Access Compliance Report

Public Rights-of-Way

(Curb Ramps)

Intersection ID: 10025574	Main Street: E_W_T_HARRIS_BV	Cross Street: N/A	Location: SE
ADA ID: 6022D42DDBA7	Ramp Type: Combination1	Initial Pass/Fail: Fail	Overall Compliance: No
			Severity Score: 21.25

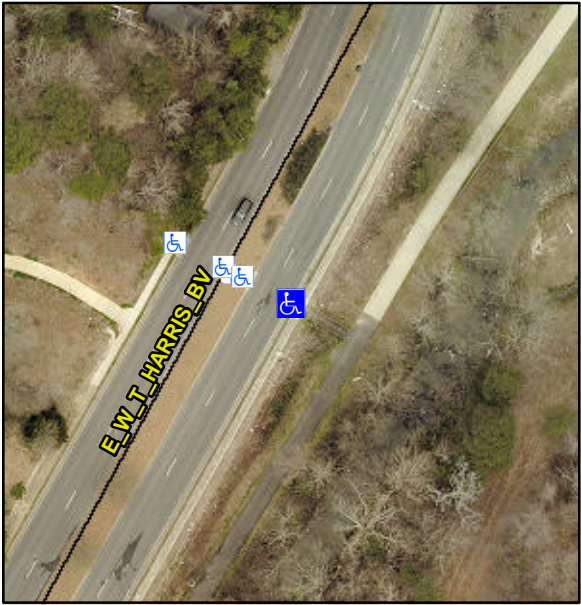
Codes/Mitigation Info/Possible Solution			Field Measurements/Component Compliance		
	Possible Solutions:		Compliance	Description	Data
	Remove & Replace Entire Ramp.		N/A	Ramp Length LT (in)	85.0
			No	Ramp Width LT (in)	47.0
			Yes	Ramp Slope LT (%)	8.0
			Yes	Ramp XSlope LT (%)	1.1
			N/A	Ramp Length (in)	24.0
			Yes	Ramp Width (in)	59.0
	Surveyor Notes:		N/A	Flare Type LT	N/A
	N/A		N/A	Flare Slope LT (%)	N/A
			N/A	Flare Traversable LT?	N/A
<p>PROW/ADA:</p> <p>R304.5.1, R304.2.2</p>			N/A	Flare Traversable RT?	N/A
			N/A	Landing Length (in)	N/A
			N/A	Landing Width (in)	N/A
			N/A	Landing Slope (%)	N/A
			N/A	Landing X Slope (%)	N/A
			N/A	Landing Curb? (Y/N)	N/A
			N/A	Shared Landing?	N/A
			N/A	Gutter Ponding?	N/A
			N/A	Gutter Lip Ht (in)	N/A
			N/A	Painted X Walk1?	No
<p>Total Cost:</p> <p>\$ 1800.00</p>			N/A	Painted X Walk2?	N/A
				X Walk 1 Direction	To NW
				X Walk 1 Width (in)	N/A
				X Walk 1 Slope (%)	5.3

X Walk 1 X Slope (%)	1.0
			N/A	Ramp inside XWalk1?	N/A
			N/A	Road Slope (%)	N/A
			N/A	Road X Slope (%)	N/A
			N/A	Ramp inside XWalk2?	N/A
			N/A	Clear Space?	N/A
			N/A	Clear Space to XWalk (in)	N/A
			N/A	Any Obstruction?	N/A
				Obstruction Type	N/A
					N/A
			N/A	Storm Grate/Utility Hazard?	N/A
				Storm Grate/Utility Type	N/A
					N/A
			Yes	Surface Condition? (G/P)	Good
				Curb Slope (%)	3.1
